601 Scottsdale Drive, Guelph

Urban Design Peer Review
Proposed Phase 2 Student Housing Development
October 31, 2024

Prepared for City of Guelph

Figure 3: Enhanced Setbacks Required by MTO

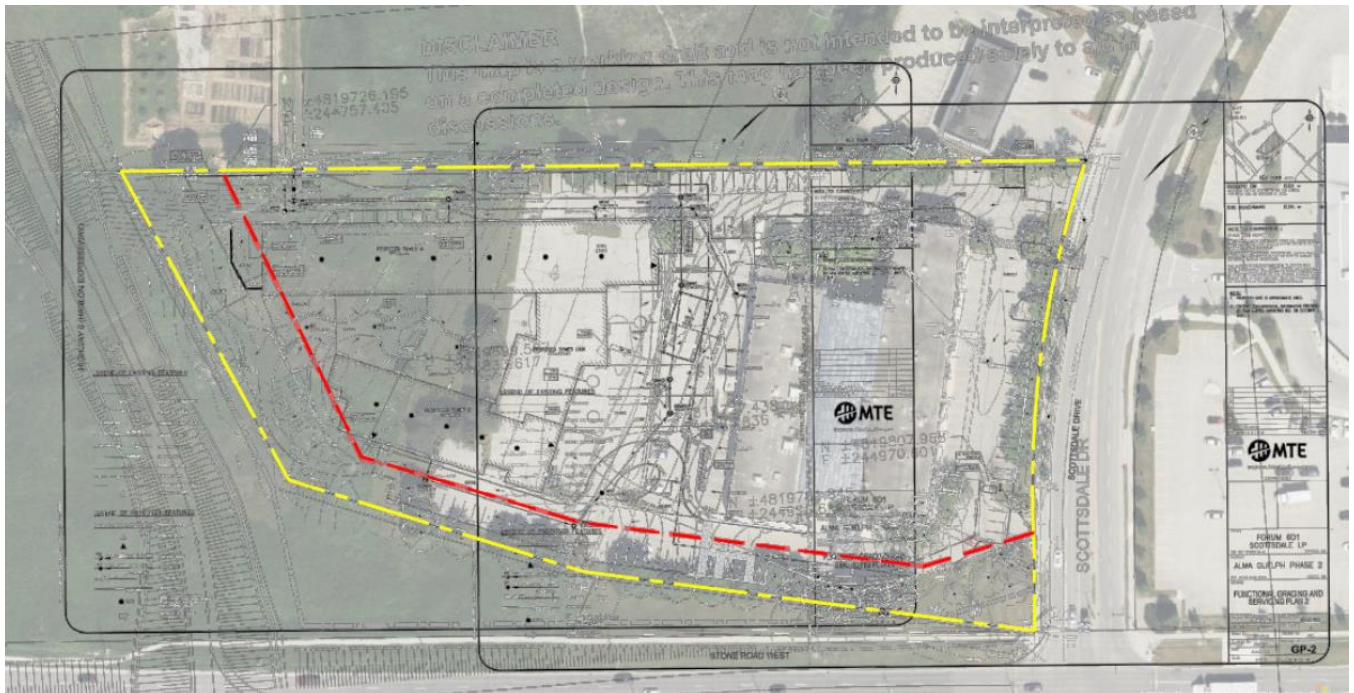
As part of the technical review of the proposed development, the Ministry of Transportation (MTO) identified the need for enhanced setbacks along Highway 6/the Hanlon Expressway (west) and Stone Road West (south/south-west) property lines for a future highway improvement project. The enhanced setbacks as prescribed by MTO are as follows:

- / 25 metres from the property line abutting Highway 6 (the Hanlon Expressway), and
- / 14 metres from the property line abutting Stone Road West

Key components of the proposed development, such as the western portions of Blocks A and B, south-side surface parking, and west-side community gardens/outdoor amenity areas, fall within the required MTO setbacks. The proposed development must therefore be reconfigured to account for the enhanced setbacks and to have consideration for how the development will interface with the future street edges along Stone Road West and Highway 6 (the Hanlon Expressway).

Figure 4: Residential Uses Anchored to the Central Shared Amenity Spaces

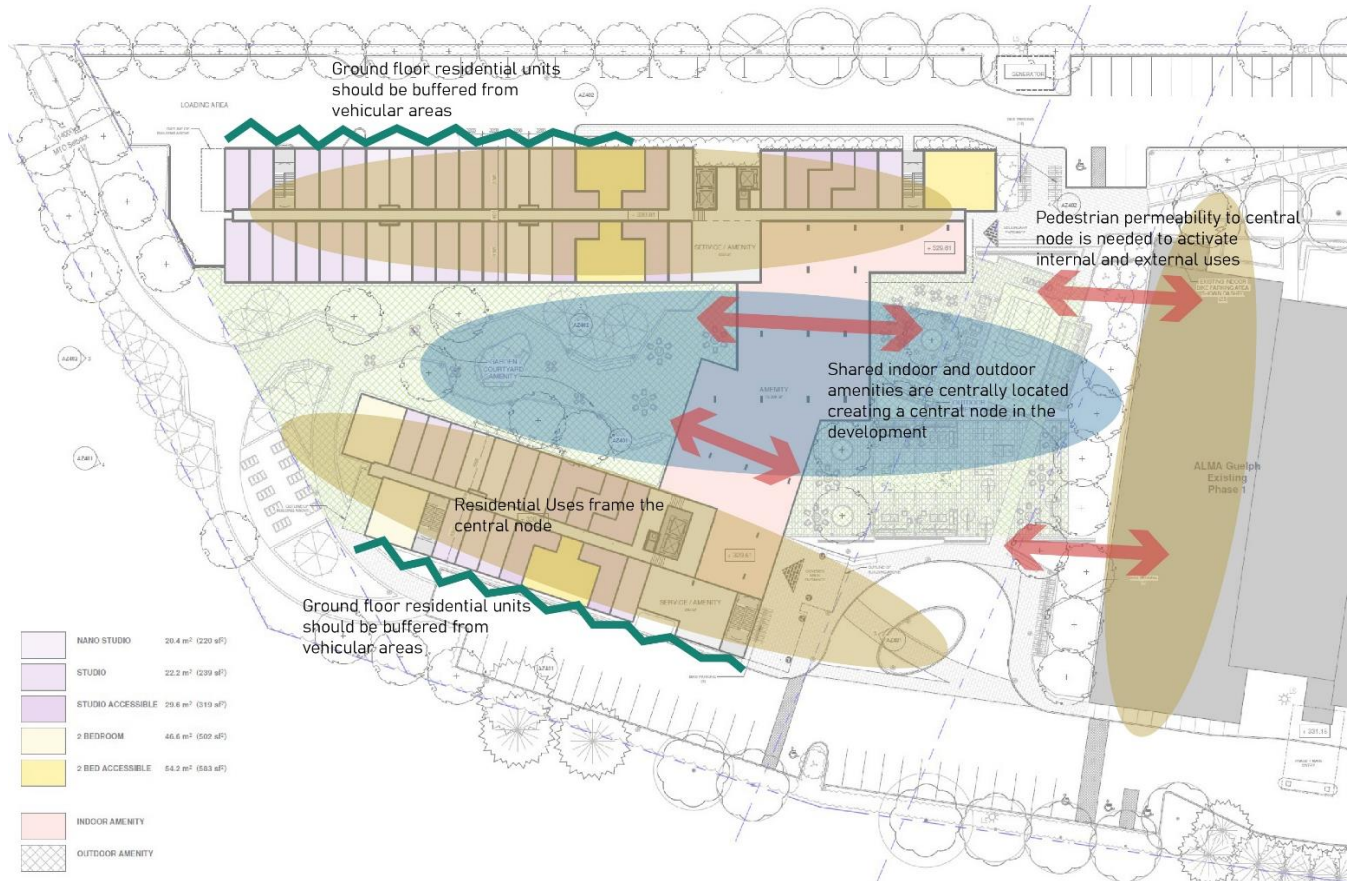
The proposed development generally anchors residential uses to shared uses in a central location within the property. This connection can be further enhanced by increasing permeability through additional entrances and defined pathways between the indoor and outdoor amenity spaces, as well as between Phase 1 and Phase 2.

While the development plan has considered the internal functioning of the property and the various proposed uses, it does not respond to or integrate well with the site's surrounding context. The proposed floor plans locate residential units along double-loaded corridors on the ground floor, directly facing high traffic areas like Stone Road West, Highway 6 (the Hanlon Expressway), and surface parking. This placement and layout could lead to reduced privacy and higher noise levels for ground floor residents. Moreover, the proposed ground floor residential use fails to activate the Stone Road West and Highway 6 street fronts, which is crucial for the site's location. It is therefore recommended that ground floor residential uses be relocated to the first floor and above.

Additionally, active ground floor uses such as cafes, restaurants, co-working spaces, gym, etc. for the exclusive use of future student residents of the development could be incorporated in the ground floor plan, particularly facing Stone Road West and Highway 6.

Figure 7: Pedestrian permeability within the site to be improved

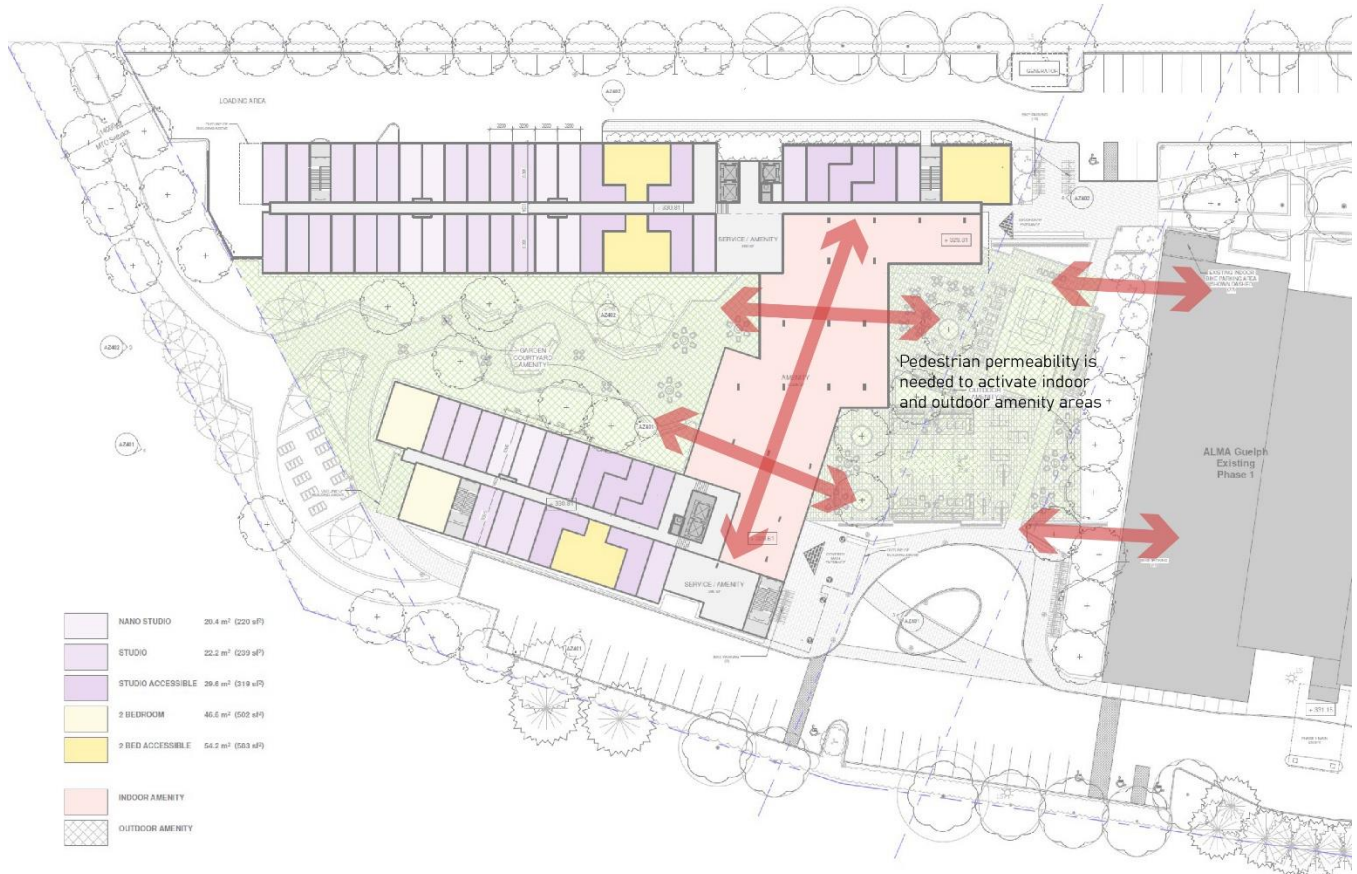
As mentioned above, the one-storey indoor amenity area divides the outdoor amenity areas/open space into two segments. The submitted drawings do not provide sufficient detail regarding entrances to the proposed indoor amenity area. However, doorways on both sides are recommended to facilitate pedestrian permeability and improved connectivity between the outdoor and indoor amenity areas, as well as the two proposed outdoor amenity areas.

Figure 8: Block B is longer than is generally recommended

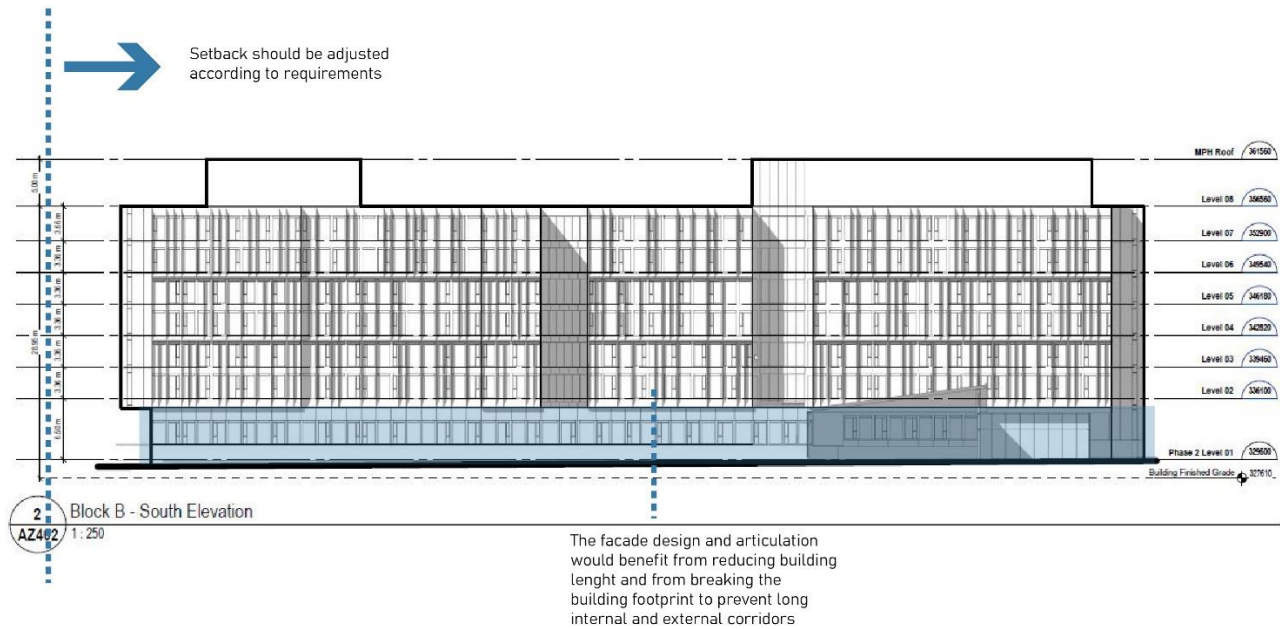
As mentioned in previous sections of this report, Block B is greater than 60 metres in length, which is the recommended length based on urban design best practices. While the proposed recesses contribute to visually breaking up the length of Block B, the facade articulation can be improved by breaking Block B into separate sections through staggering or an L-shaped building footprint.

Figure 11: Conceptually Revised Typical Floor Plan and Site Plan

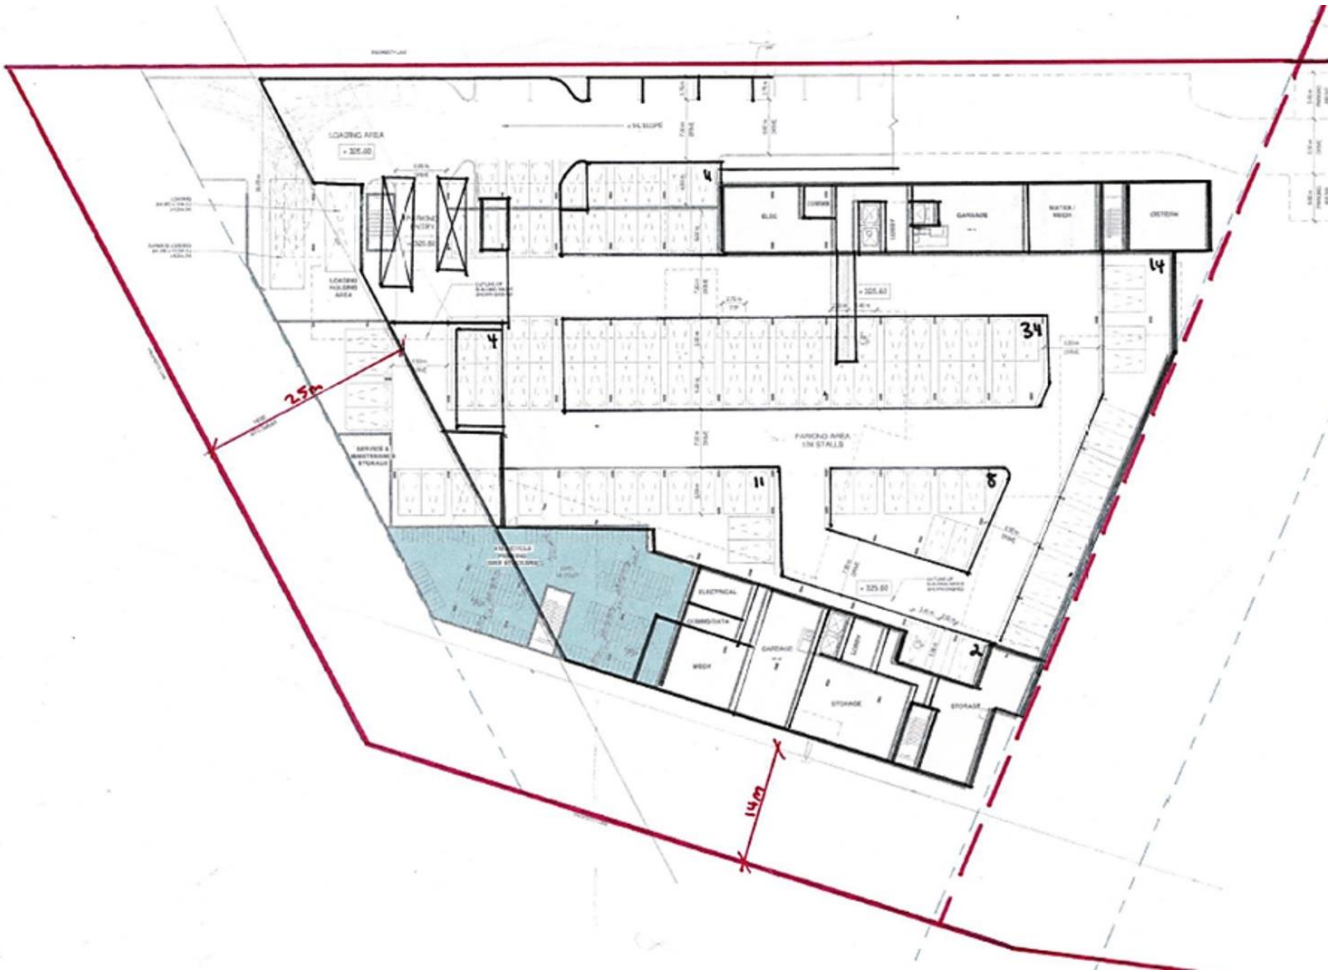
Based on the MTO comments, dated February 26, 2024, alternate site configurations must be explored to meet the required enhanced setbacks. As part of this peer review, Fotenn explored alternative site configurations using the submitted site plan and floor plans and applying the required MTO enhanced setbacks. The intent of this exercise was to identify ways in which the proposed development plan can respond to the MTO requirements with minimal modifications to the submitted plans.

Although the above changes would help address the MTO requirements, it could potentially result in the loss of:

- / Approximately 84 units (Block A - 8 units x 7 storeys, and Block B – 4 units x 7 storeys);
- / Approximately 34 surface parking spaces;
- / Approximately 19 spaces in the partially underground parking structure;
- / Approximately 30-40% of proposed bicycle parking spaces;
- / A portion of landscaped amenity area.

As such, Fotenn presents the following revisions to the proposed plans (as show in Figure 10 and Figure 11) for the Owner/Applicant's consideration:

- / Scale back western portions of the proposed Blocks A and B to achieve a 25 metre setback from the western property line;
- / Scale back the western side of the partially underground parking structure to achieve a 25 metre setback from the western property line;
- / Shift the proposed loading area and parking entry further east;

- / Resize the proposed bicycle parking area to fit within the new parking floor plan;
- / Relocate western staircases of Blocks A and B to fit within the new floor plans;
- / Eliminate the proposed extension to the south-side driveway to achieve a 14 metre setback from the southern property line(s);
- / Relocate the proposed main entrance from the east side of Block A to the east side of Block B.

- / Increase the building heights for Blocks A and B to at least 9-storeys but no greater than 14-storeys;
- / Extend the partially underground structured parking level to two (2) levels of parking either below ground or within a podium parking level.
